**Building #046 Renovations**  
**For**  
**College of Social and Applied Human Sciences**  
Project No. 504034 Post

**POST TENDER ADDENDUM 4**

**March 21 , 2019**

PROJECT:		UNIVERSITY OF GUELPH - BUILDING #046 RENOVATIONS GUELPH, ONTARIO	
DRAWING:		REVISED SECTIONS AND DETAILS	
 ENGINEERS · ARCHITECTS · PLANNERS www.jlrichards.ca	DESIGN: DAY/JRE	PT ADDENDUM No. 4	
	DRAWN: BCW	DRAWING #:	
	CHECKED: LS	SKS71-1	
	JLR #: 27915

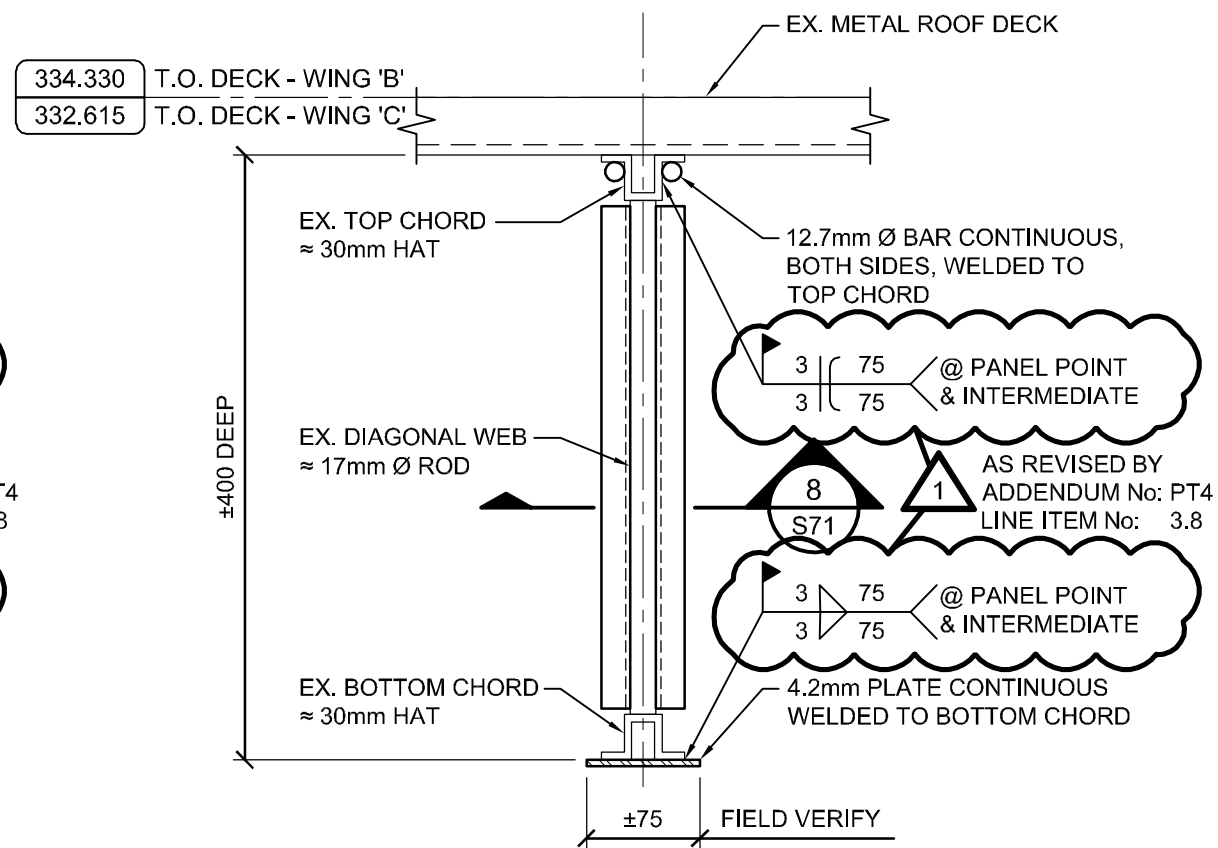
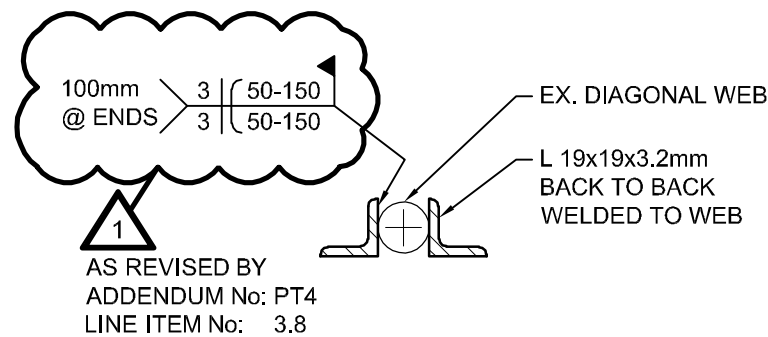
**PT-4.8 Q2:** Regarding the OWSJ reinforcing shown on S14, S41 & S71 details 3,4 & 8 call for continuous welds. Typically this is done as a specific stitch weld which would greatly reduce the welding labour. Please confirm if we are to allow for continuous welds and or provide a Revised set of drawings with new welding details.

**A2:** Please refer attached sketch SKS71-1 provided with this Addendum for clarification on welding details at referenced locations.

**3 FLOOR JOIST REINFORCING DETAIL**  
 S71 SCALE: 1:5  
 NOTE: CONTRACTOR TO FIELD VERIFY DIMENSIONS.

**4 ROOF JOIST REINFORCING DETAIL**  
 S71 SCALE: 1:5  
 NOTE: CONTRACTOR TO FIELD VERIFY DIMENSIONS.

**8 WEB REINFORCING SECTION**  
 S71 SCALE: 1:2.5
